**Amended  
Site Master Plan**

The Summit At University Executive Park

**CHARLOTTE-MECKLENBURG  
PLANNING COMMISSION**  
INTER-OFFICE COMMUNICATION

SUBJECT: Administrative Approval for Petition No. 88-18(c) Harris Boulevard  
Partners Tax Parcel No. 047-211-09

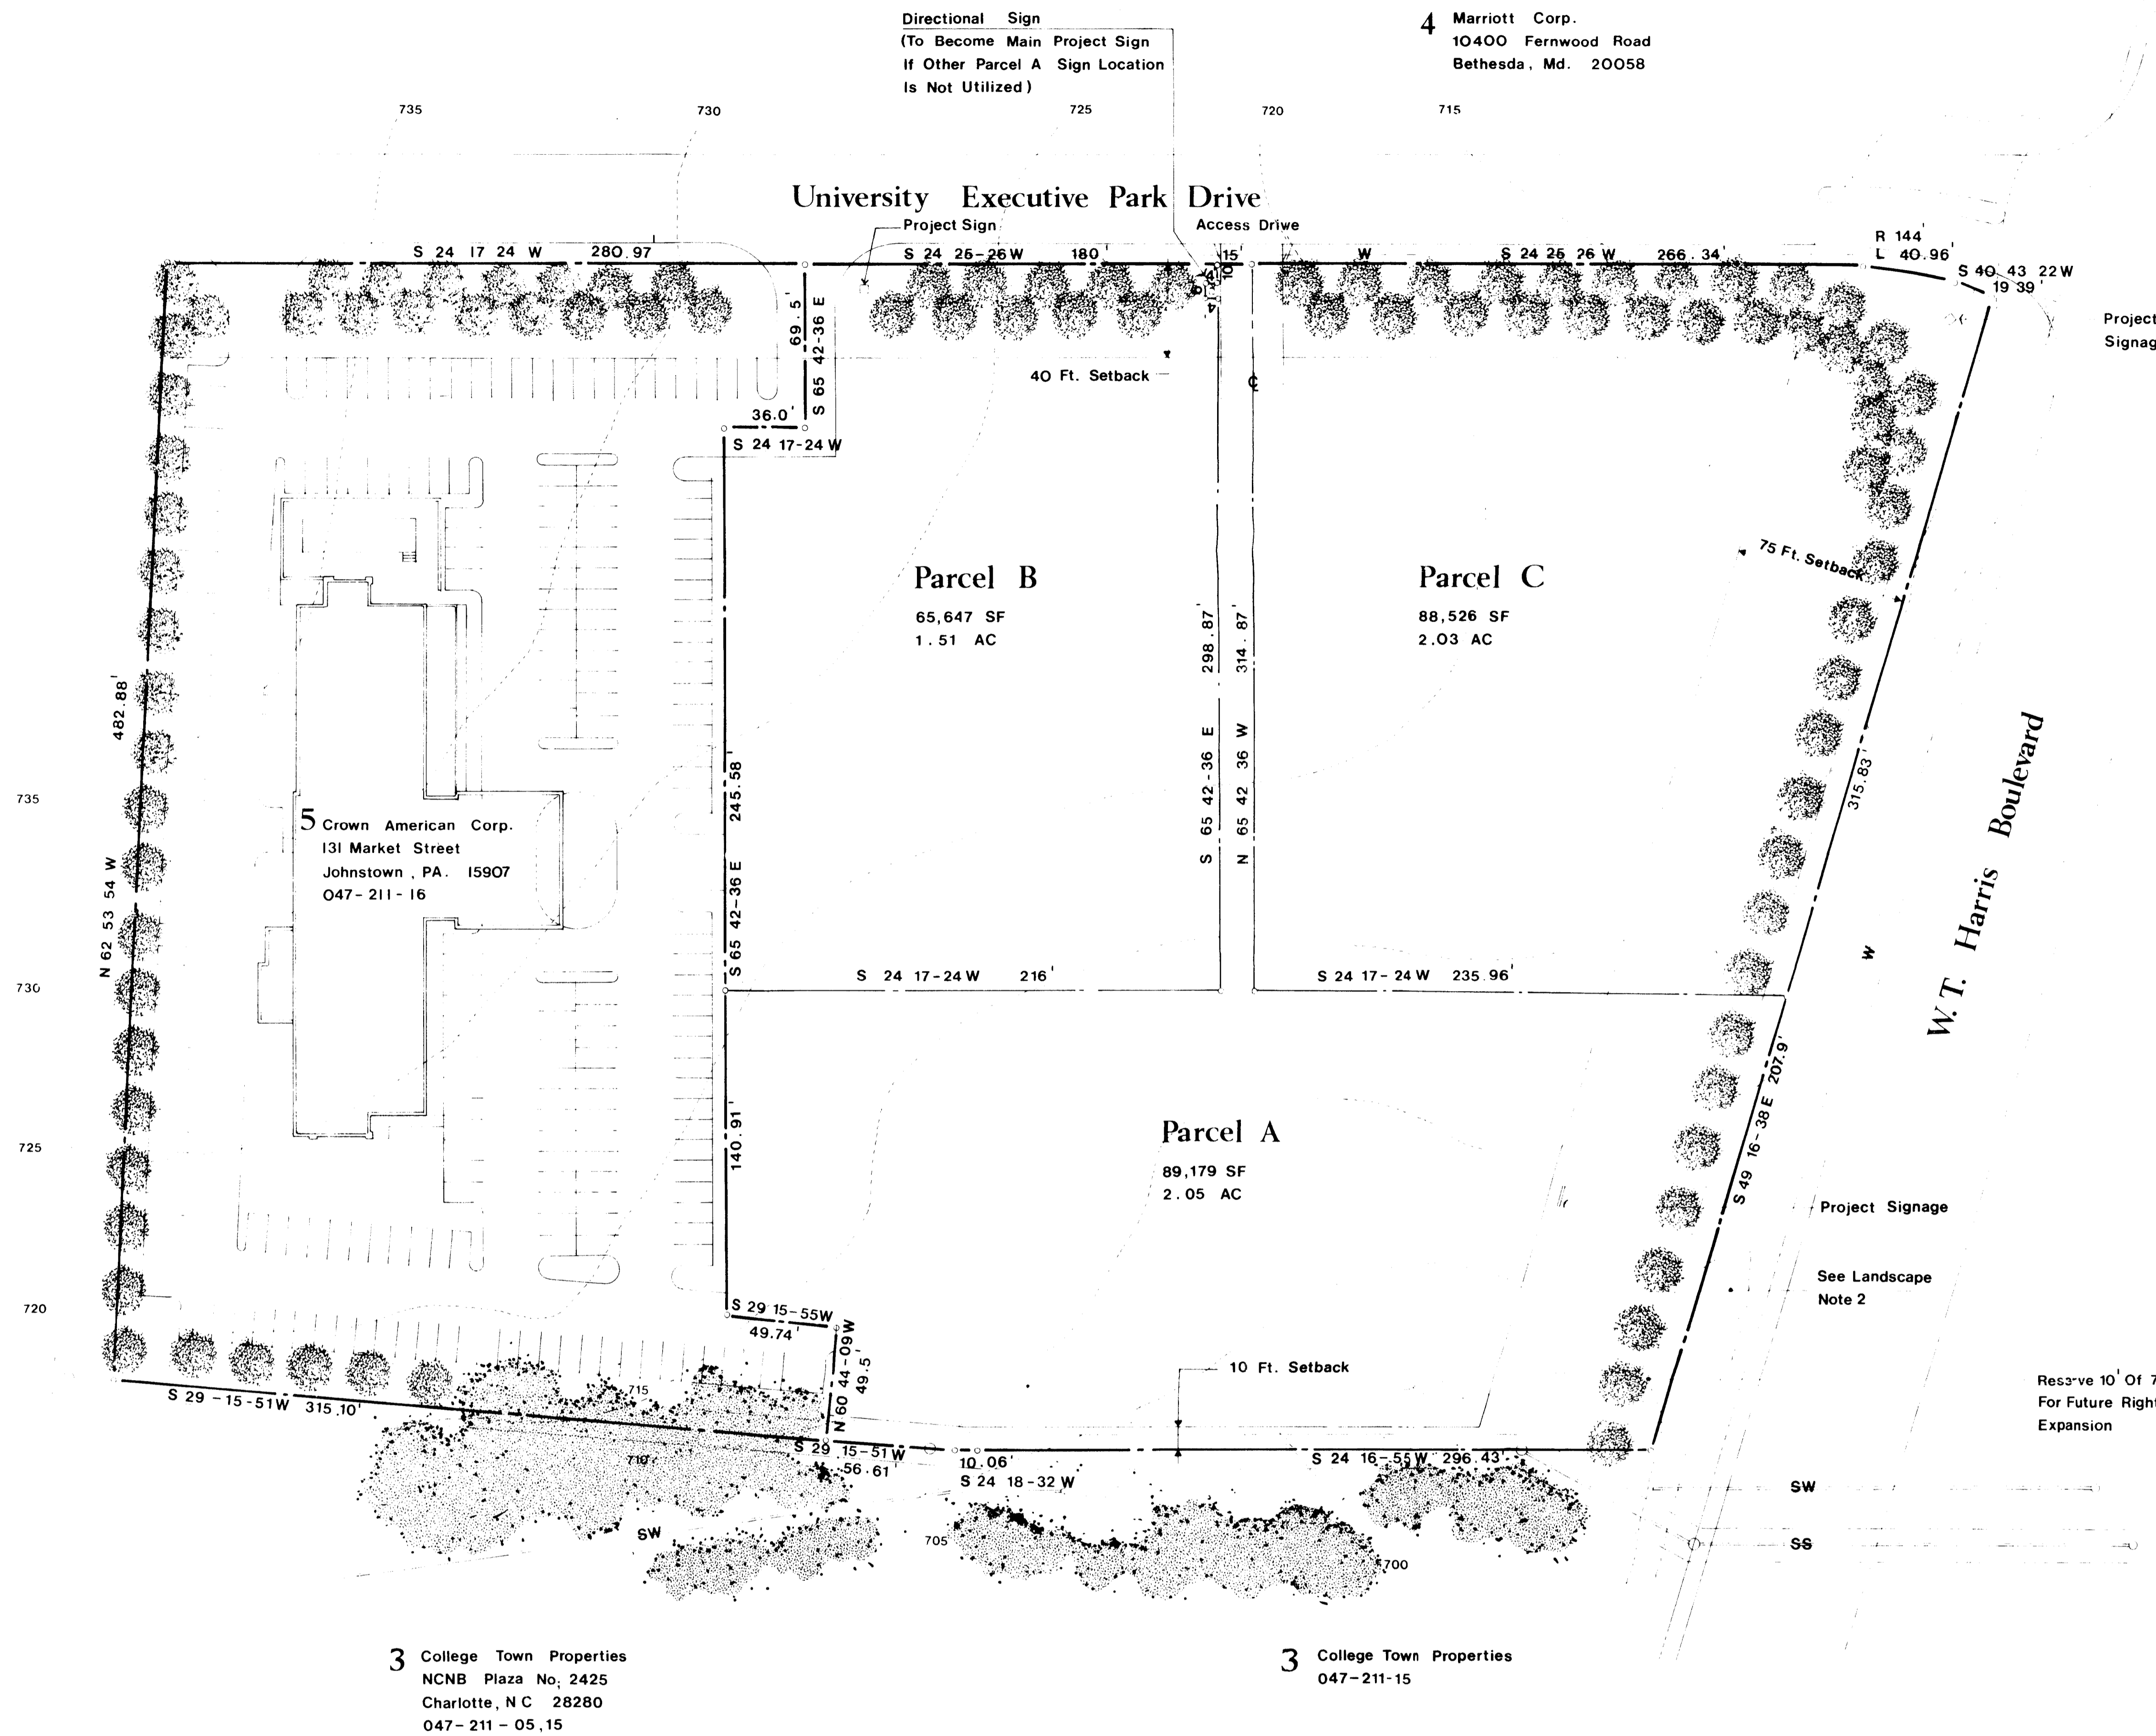
Attached is a revised master plan of the above mentioned rezoning petition. The plan has been revised to show four building sites. One building site is occupied by the existing hotel. The other three will be occupied by office buildings, not to exceed 120,000 square feet. All the yards and setbacks will remain as previously approved. Since these changes are minor and do not affect the yards at the exterior of the property, I am administratively approving this plan. Please use this plan when evaluating requests for building permits and certificates of occupancy.
